DRAFT UN Regulation No. [X]**Uniform provisions concerning the approval of vehicles with regard to automated lane keeping system**

- **Green highlight text:** incorporating the proposals in ACSF-24-18 (UK/DE/Industry)
- **Blue highlight text:** incorporating (some parts of) the additional changes proposed by UK/EC after the IWG, and some additional text/modifications based on the IWG discussion (with some editorial changes (reference no. etc.) and notes)
- **Bold & underlined text:** incorporating the EC text from ACSF-24-08

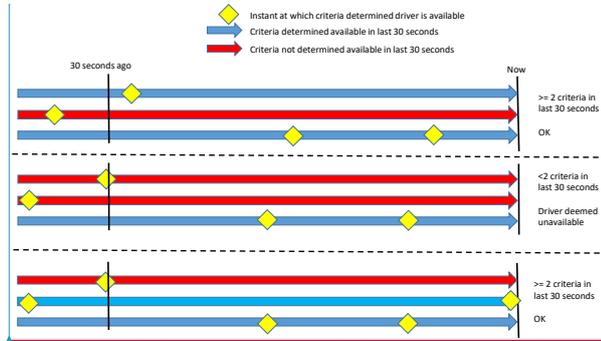
Kommentiert [JR6]: New graphic as per powerpoint presentation to be inserted (white lines before the 30 second marker)
Feldfunktion geändert
